**Flood Control Project Maintenance
Levee Inspections**

2016 Channel Summary Report

Adin Community Service District

Photo 1 of 2 : CH_2016_NA0030_1_36_20160726_00014.jpg

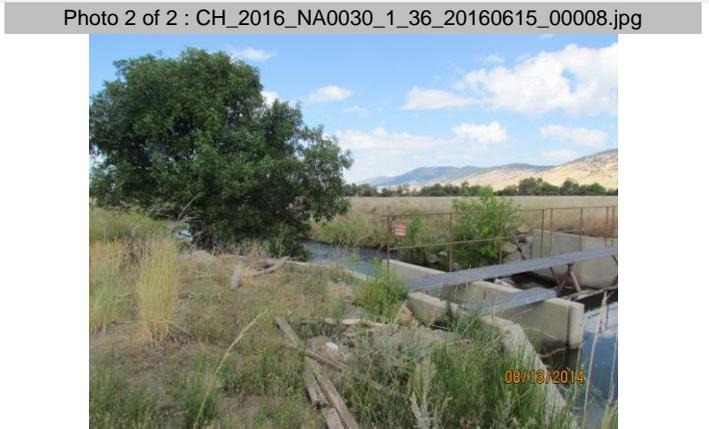
Check Point / View			
Downstream limit/fish ladder & walkway / Down			
Rating **	A	Issue No.	36
Issue Type +	Ma	Location *	41.192990°
Category	Rivers, Channels & Designated Flood		-120.954530°
Item	Vegetation & Obstructions		
DWR ID	DWR_NA0030_1_c_2012_36		
Action/Comments			
Inspector Comments: The channel is clear of vegetation & obstructions.
